# Lake Chelan GRP

2023 Update

# LKCH 108.5 Lucerne Landing

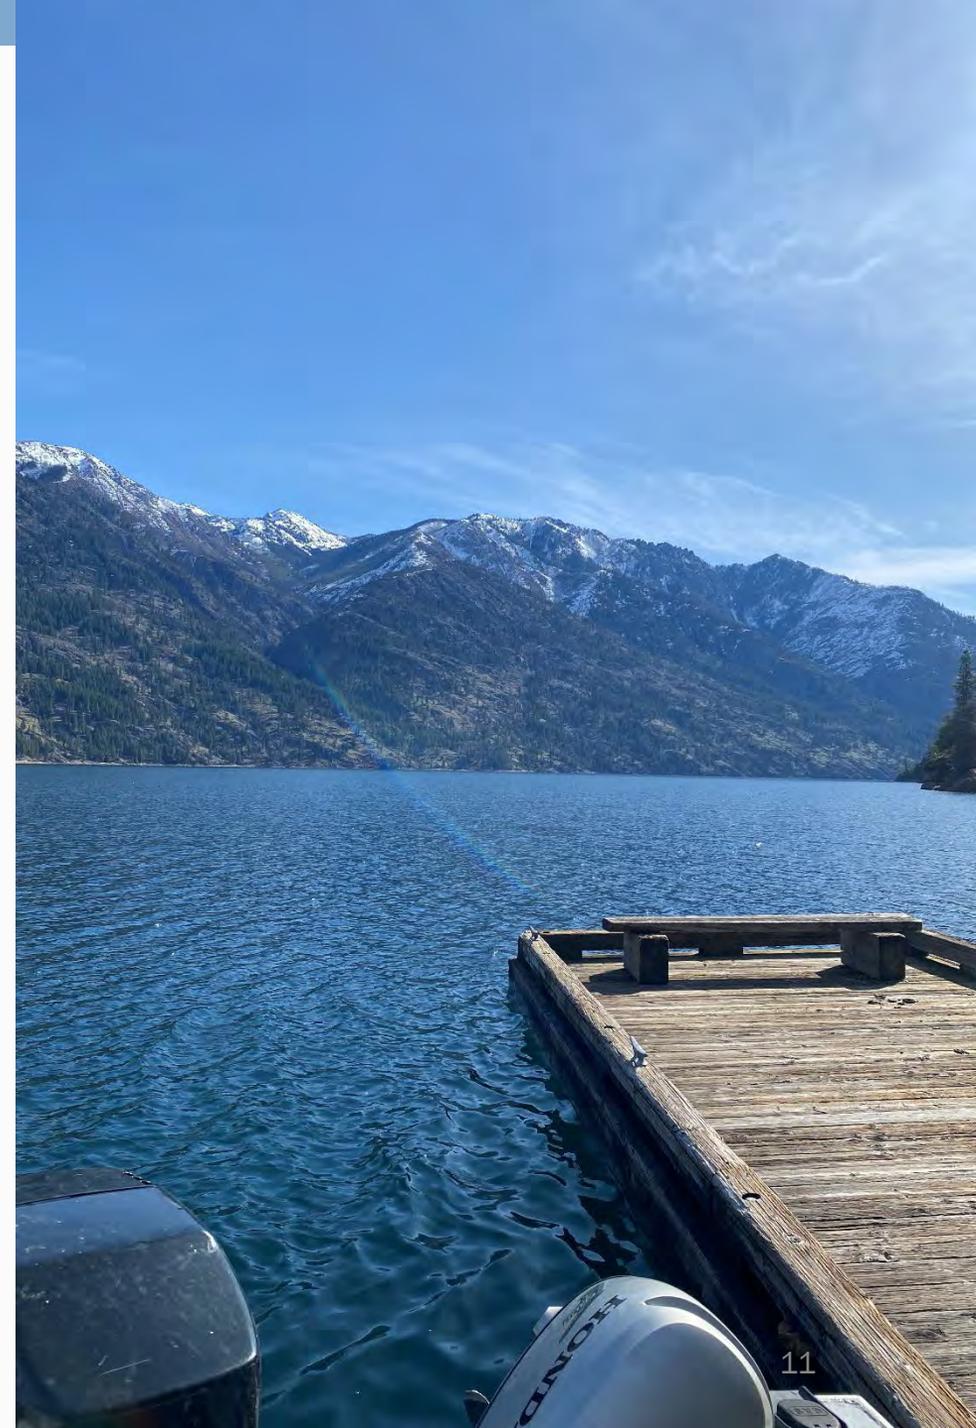
- Containment, 500' boom
- Issues/Concerns: Redundant of strategy 108.5
- Recommendation: Removal
- Recommended by: Planners

# LKCH 116.0 Painted Rocks

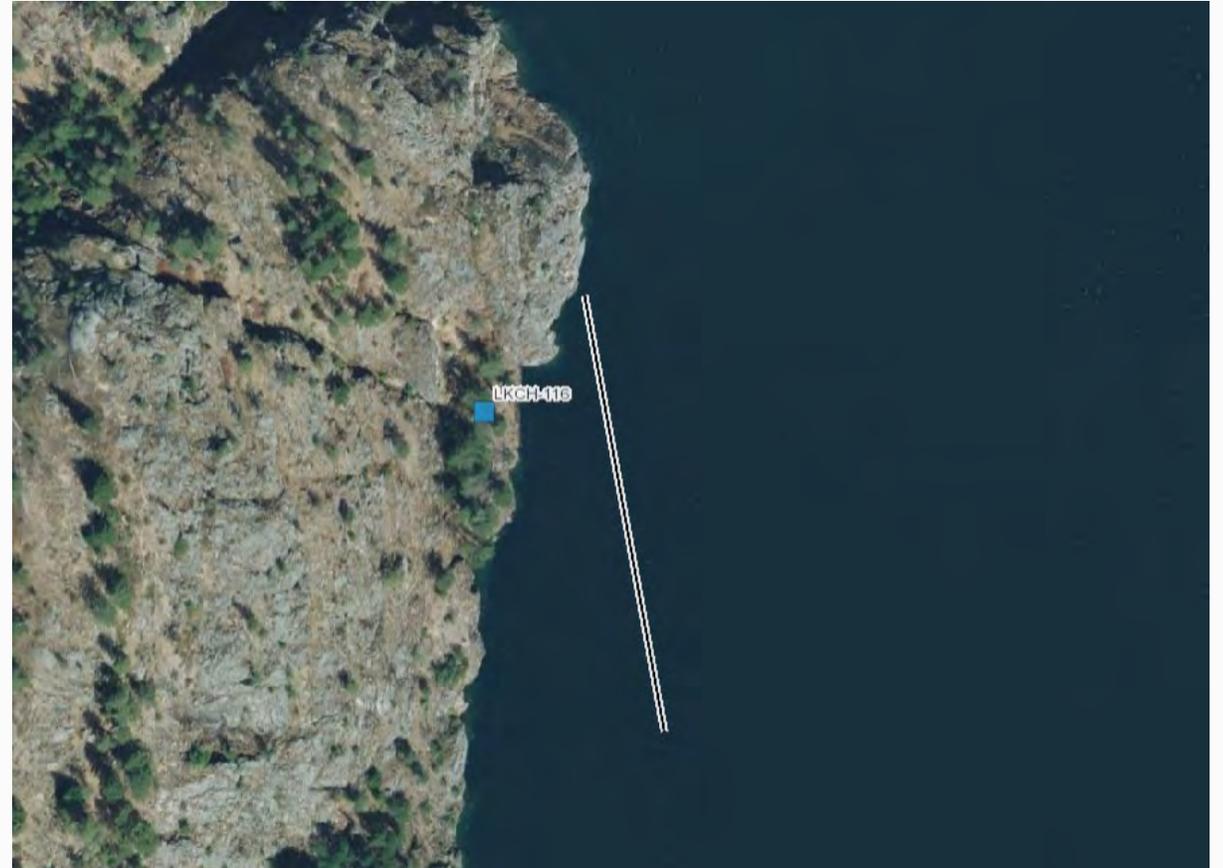
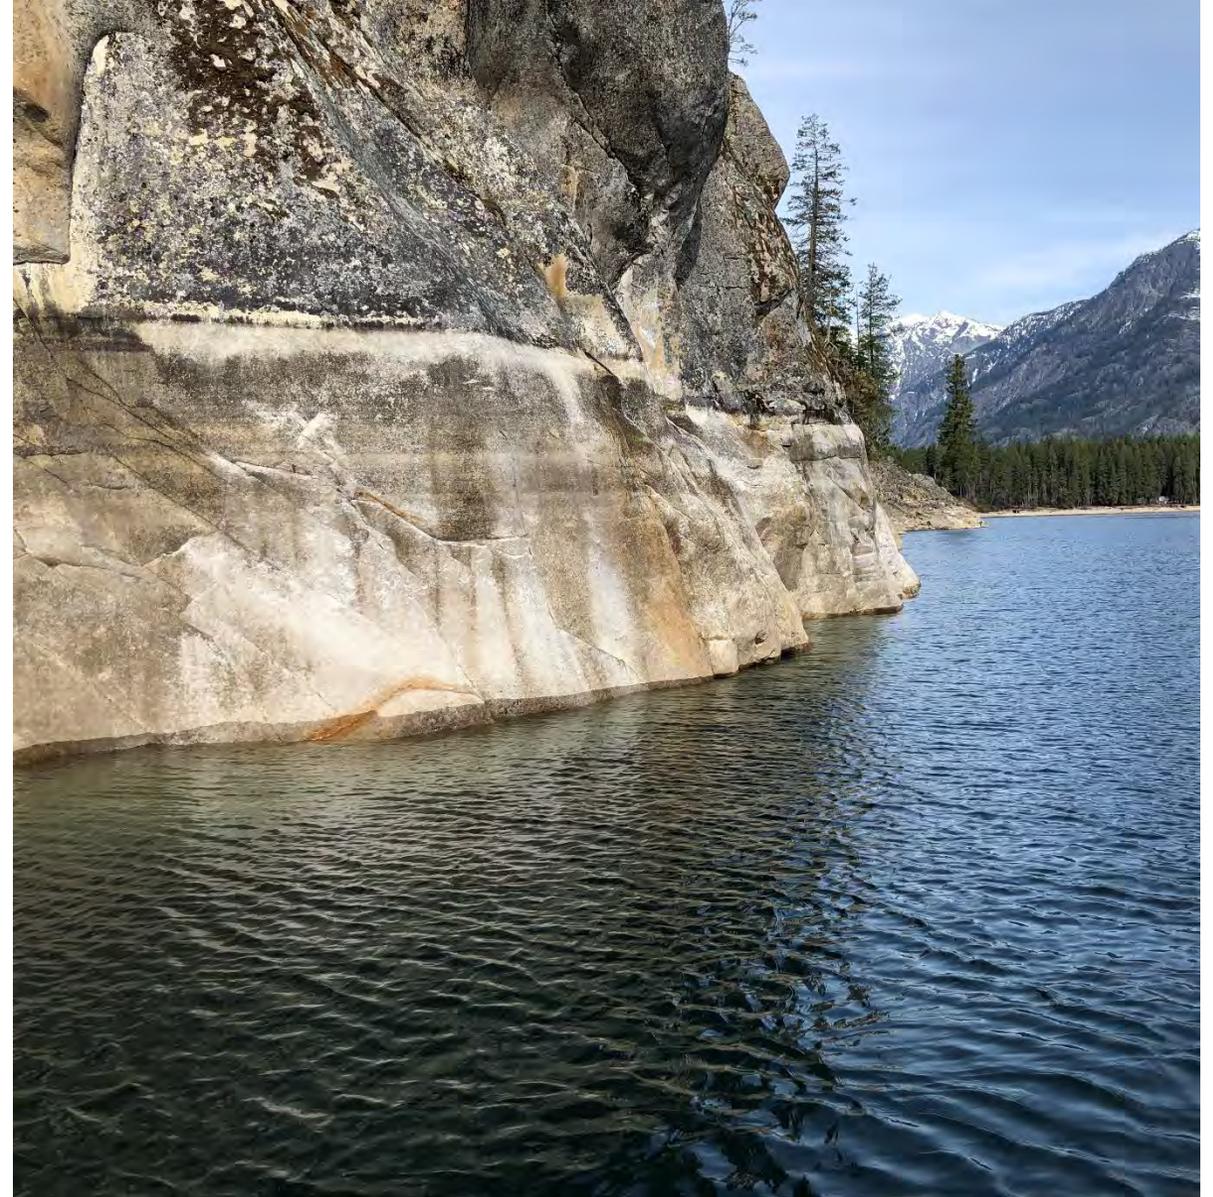
- Exclusion, 500' boom
- RAR: Cultural Resources
- Issues/Concerns: Delicate area, difficult to deploy boom
- Recommended by: NPS, Planners

# LKCH 104.4 Lake Chelan

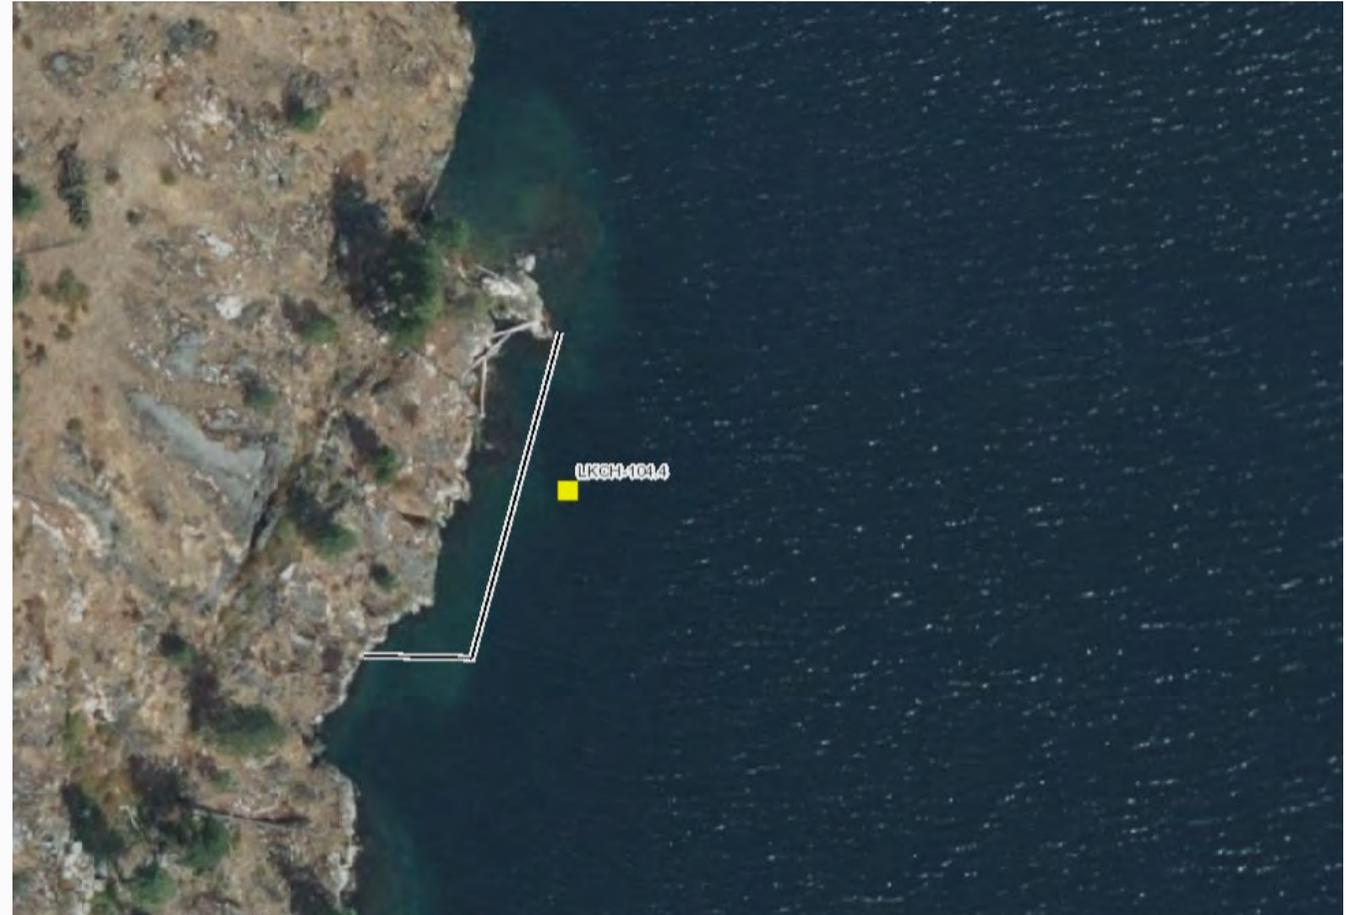
- Exclusion 250' B3 boom
- Issues/Concerns: Update boom/length to reflect current practices.
- Recommendation: 300' B2
- Recommended by: Planners
- RAR: Sensitive cultural resource

# LKCH 61.0 Lake Chelan (Chelan)

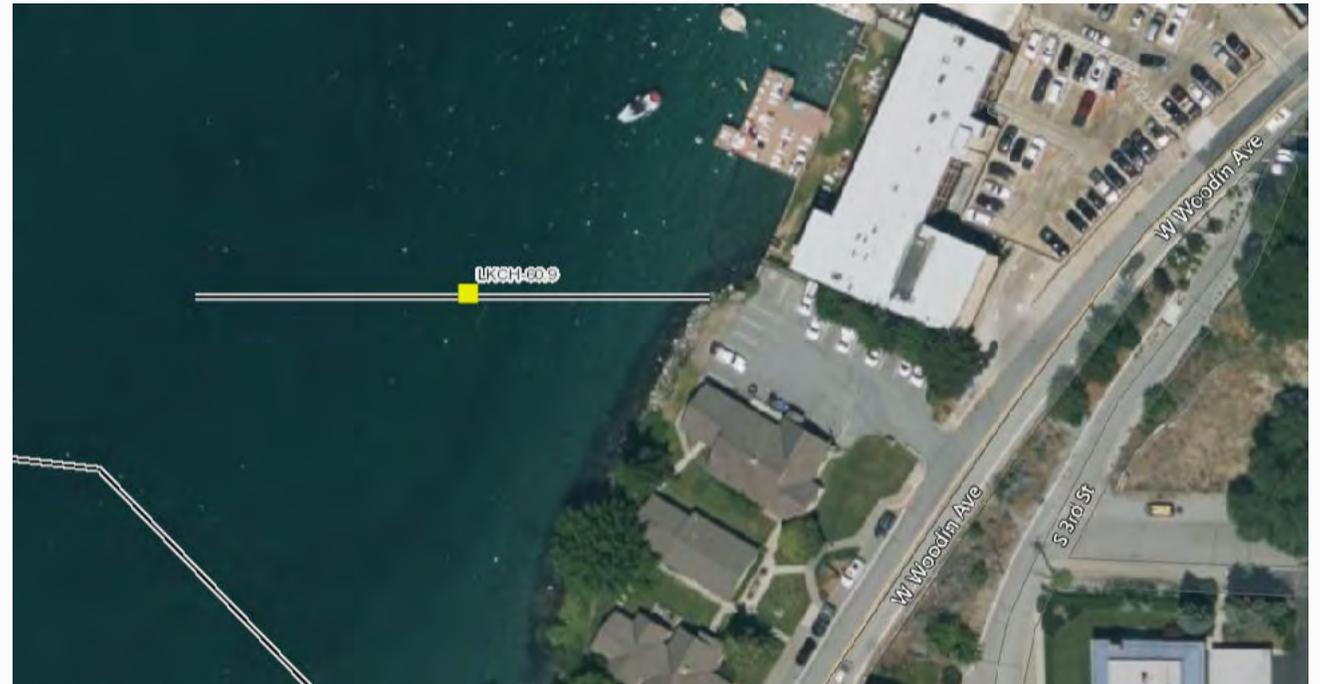
- Collection 500' B3 boom
- Issues/Concerns: Adjust boom angle to better facilitate collection
- Recommendation: 500' B2
- Recommended by: Planners
- RAR: Power generation
